SUBDIVISION COMMITTEE
METROPOLITAN AREA PLANNING COMMISSION

STAFF REPORT
(Final Plat)

CASE NUMBER: S/D 95-29 THE DUGAN CENTRE THIRD ADDITION

EXHIBIT "B"

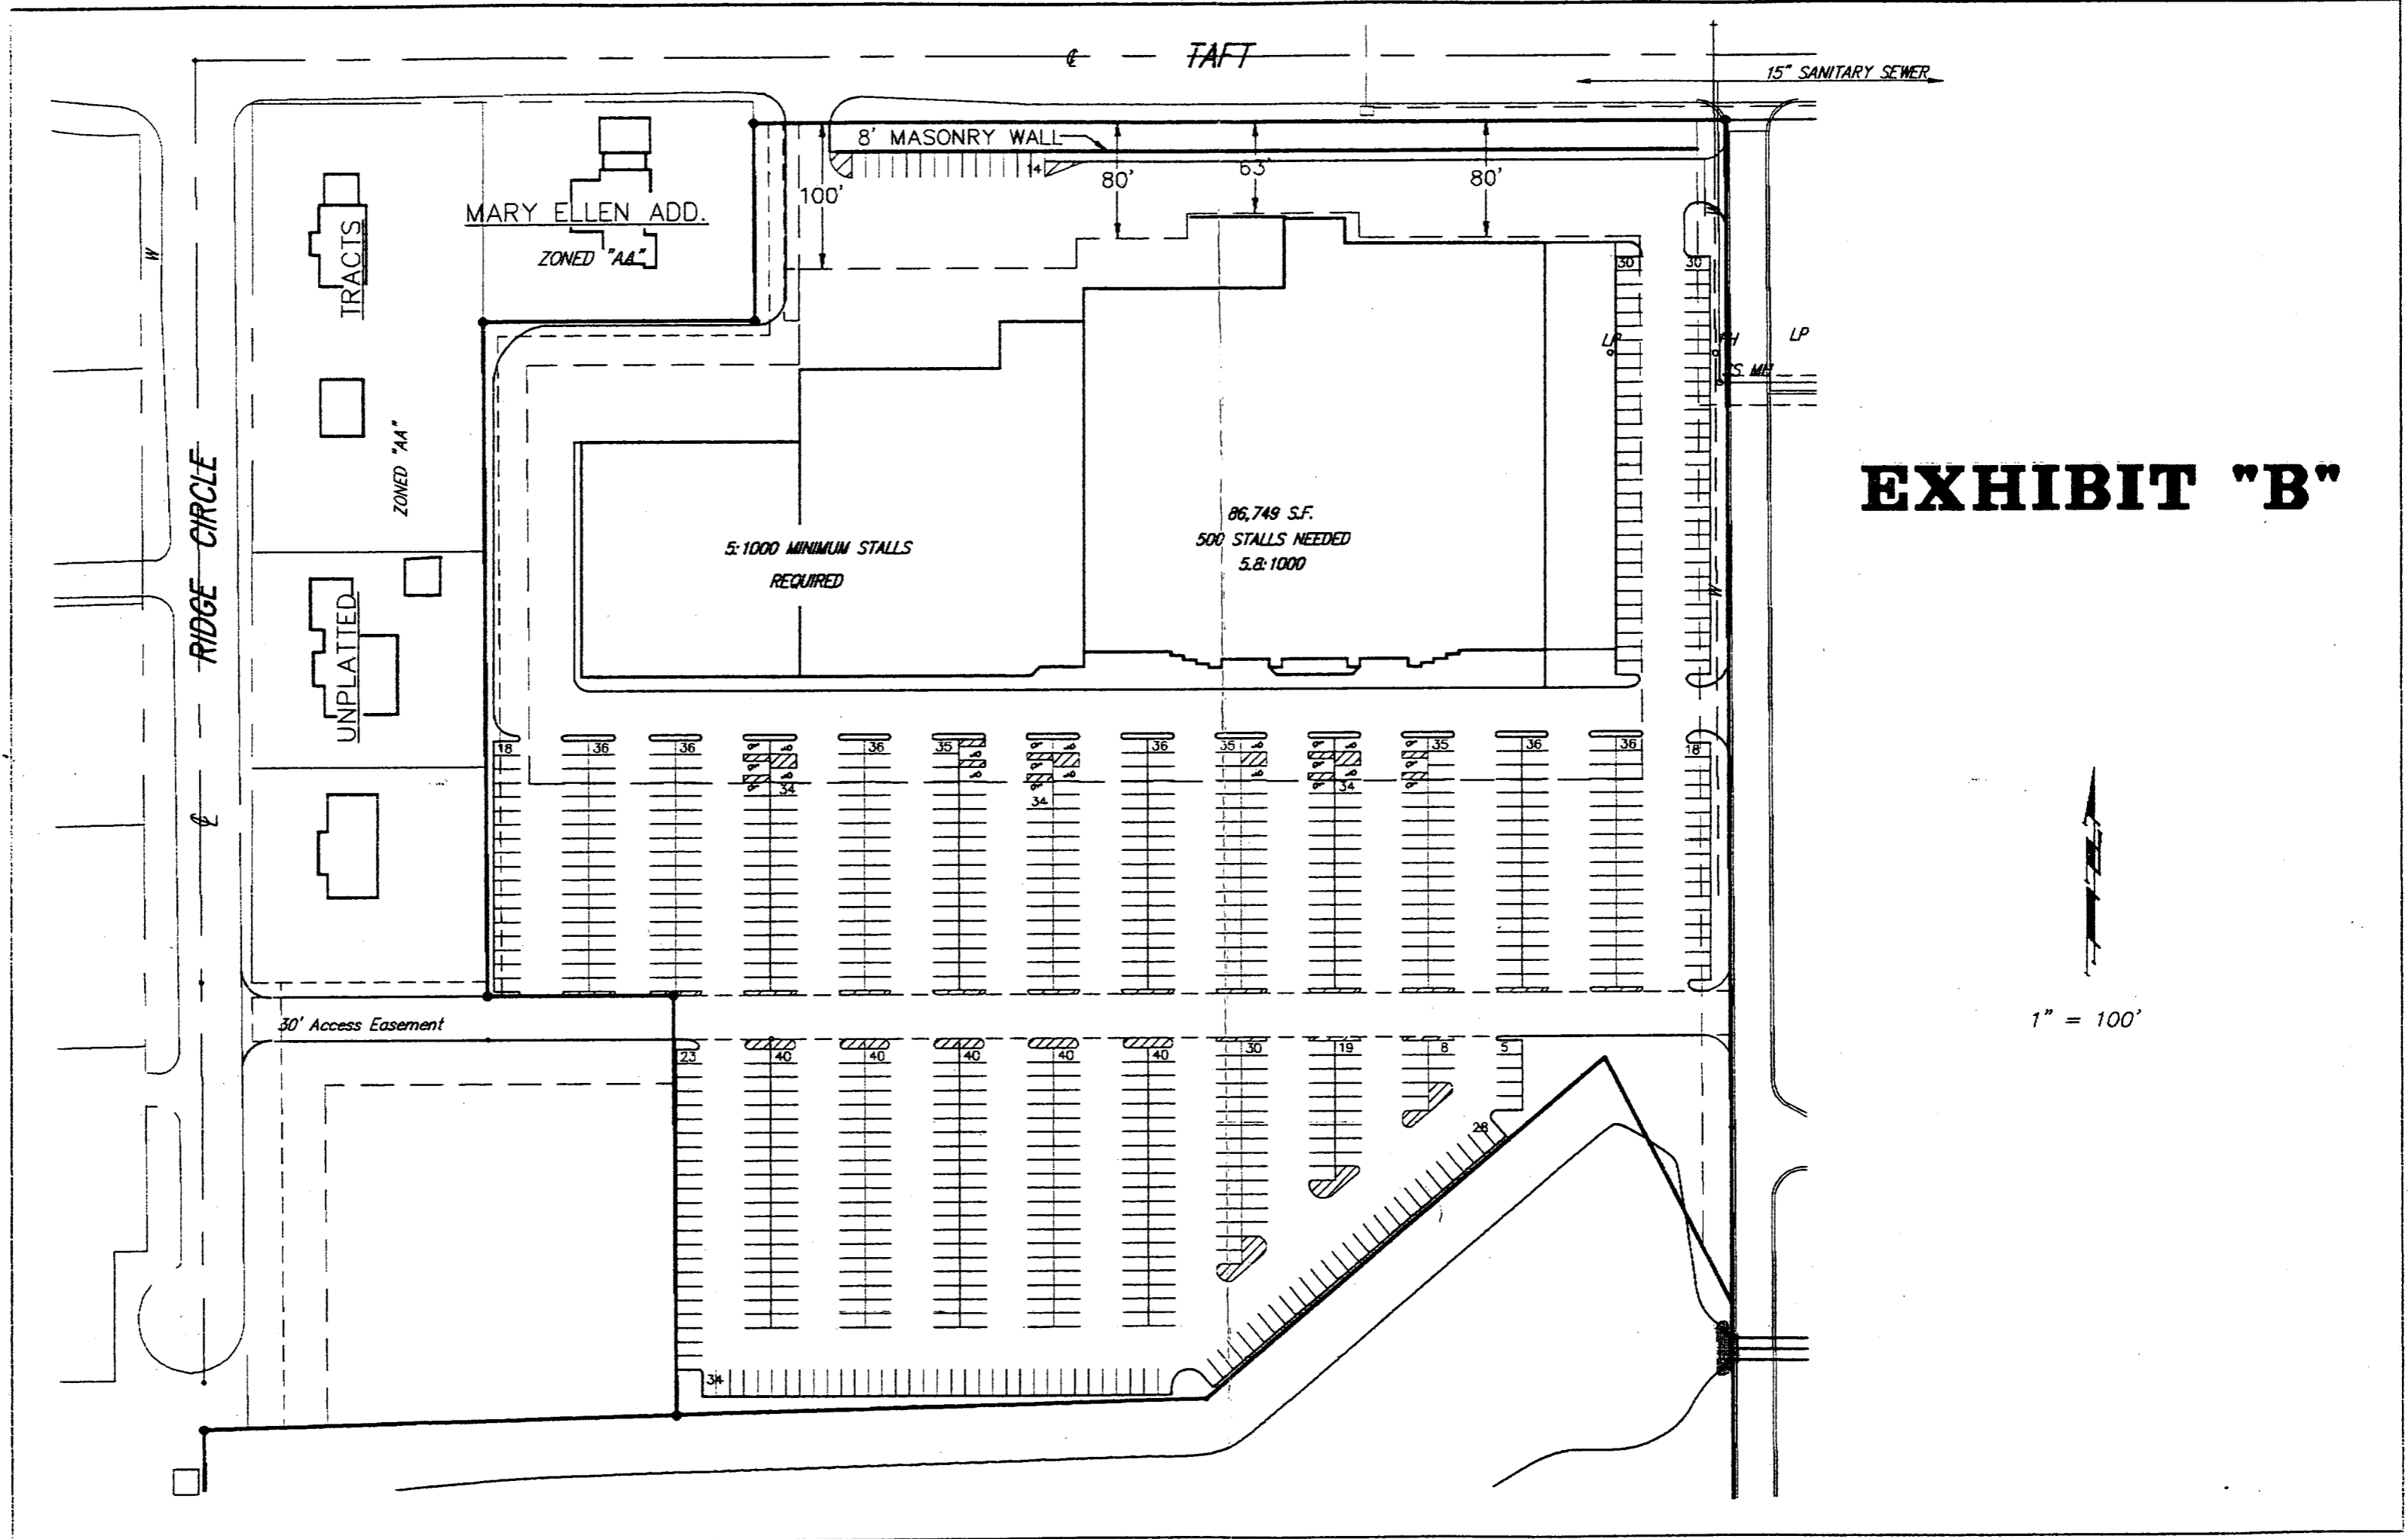
- A. This plat will be subject to approval of the CUP and any relevant conditions. The plat will not be scheduled for City Council review until approval of the CUP has been completed.

- B. In addition to standard requirements for the extension of sanitary sewer and water, when the original Dugan Centre plat was reviewed numerous requirements for drainage, adjacent street paving, intersection, traffic, etc. improvements were established. City Engineering and Traffic Engineering need to indicate if this replat now requires any additional guarantees and/or the provision of agreements concerning the existing guarantees.

- D. City Engineering needs to indicate if any additional right-of-way requirements exist for this site, particularly as regards Kellogg and Kellogg Drive.

- E. On the final plat tracing, the face of the plat shall indicate the presence of Kellogg Drive and Kellogg adjacent to the south end of this plat. It shall also be indicated that complete access control exist between Kellogg Drive and Kellogg.

- F. A preliminary review of the CUP indicates that this site is expected to have only one (1) allowed opening to Taft. Both the face of the plat and plattor's text shall note this dedication of such access control.

- G. In regard to building setbacks, the CUP is indicating a 60-foot setback along the east line of Lot 1 and a "stepped" typed setback along the north line. If these are the setbacks for the approved CUP, the final plat tracing shall also plat such setbacks.

- H. The platting of minimum building pad elevations shall also be shown on the face of the final plat tracing. Such information is typically included below the north arrow.

- I. The final plat tracing shall show the recording information for the access easement. This is a private easement and shall be recorded by the applicant with a copy of the recorded easement submitted to Planning for the plat file.

In regard to the existing access easement, this is not a public easement and cannot be vacated by this replat. The applicant shall submit documentation that all parties benefitting from or involved in this access easement are agreeable to the proposed changes. That is, a release of this easement needs to be obtained, with proof of such a release being provided to Planning.

- J. Provisions shall be made for ownership and maintenance of the proposed reserves. The applicant shall either form a lot owners' association prior to recording the plat or shall submit a covenant stating when the association will be formed, when the reserves will be deeded to the association and who is to own and maintain the reserves prior to the association taking over those responsibilities.

- K. For those reserves being platted for drainage purposes, the required covenant which provides for ownership and maintenance of the reserves shall grant, to the City, the authority to maintain the drainage reserves in the event the owner(s) fail to do so. The covenant shall provide for the cost of such maintenance to be charged back to the owner(s) by a method similar to special assessments.

- M. The applicant shall submit an avigational easement covering all of subject plat and a restrictive covenant assuring that adequate construction methods will be used to minimize the effects of noise pollution in the habitable structures constructed on subject property.

- N. The applicant shall install or guarantee the installation of all utilities and facilities which are applicable and described in Article 8 of the MAPC Subdivision Regulations. (Water service and fire hydrants required by Article 8 for fire protection shall be as per the direction and approval of the Chief of the Fire Department.)

- P. Perimeter closure computations shall be submitted with the final plat tracing. Section 5-101(c).
- Q. Recording of the plat within 30 days after approval by the City Council.

- R. The representatives from the utility companies should be prepared to comment on the need for utility easements to be platted on this property.
- S. The representatives from City Engineering should be prepared to comment on the status of the applicant's drainage plan.
